**MONITORING REPORT**  
**2023 (Year 5)**

**MAJOR HILL STREAM AND WETLAND MITIGATION SITE**

## **Response to Monitoring Year 5 (2023) DMS Comments**

Major Hill Mitigation Site  
DMS Project ID No. 100015  
Full Delivery Contract No. 7193  
USACE Action ID No. SAW-2017-01472  
DWR No. 17-0921  
RFP No. 16-006990

**Figure 3: Map of Record Overview**

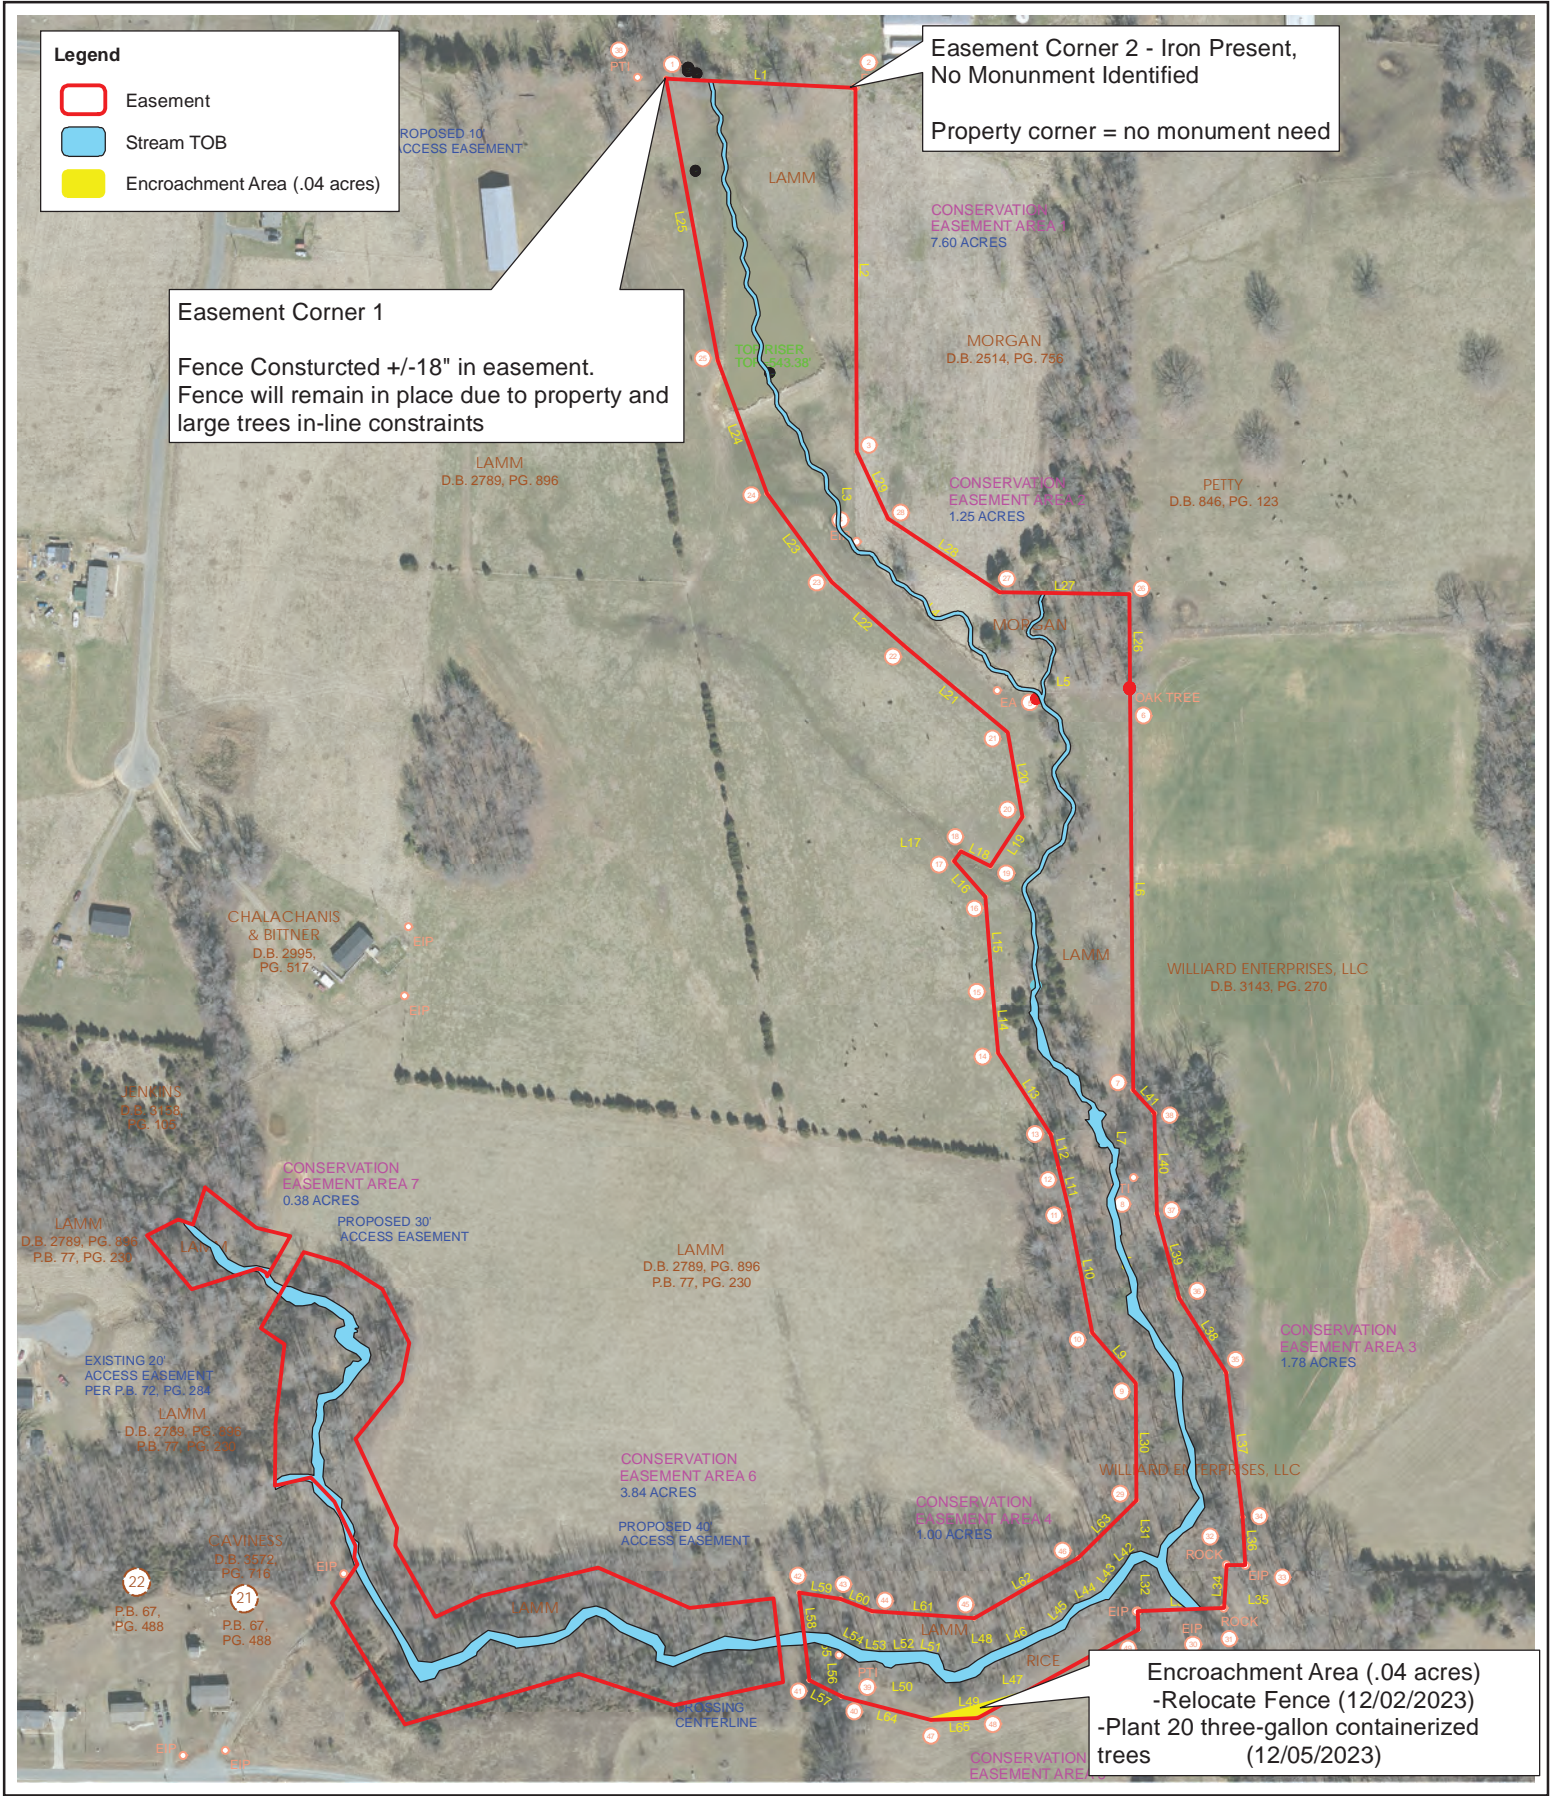
- During the NC DMS boundary inspection with Danielle Mir and Jeff Horton on September 21, 2023, multiple issues were discovered. No conservation easement placards were visible across the entire property. One section of fence located at easement corner 1 was constructed +/-18 inches within the easement, see on Figure 3 (Appendix H). Easement corner 1 appeared to be improperly stamped. One stamped easement cap was not located at easement corner 2, see Figure 3 (Appendix H.)

- Resolutions:  
On September 27<sup>th</sup>, 2023, RS staff members performed a comprehensive boundary inspection. While performing the inspection, conservation easement placards were installed at each corner of the easement, see Photo Log (Appendix H.) The section of fence constructed inside the easement is determined to remain in place due to property boundary constraints and large hardwood trees in line with the easement boundary, see NC DMS Email Response (Appendix H). Easement corner 1 is stamped appropriately according to the NC DEQ Guidance, see Easement Inspection Photo Log

Encroachment Area (.04 acres)  
-Relocate Fence (12/02/2023)  
-Plant 20 three-gallon containerized  
trees (12/05/2023)
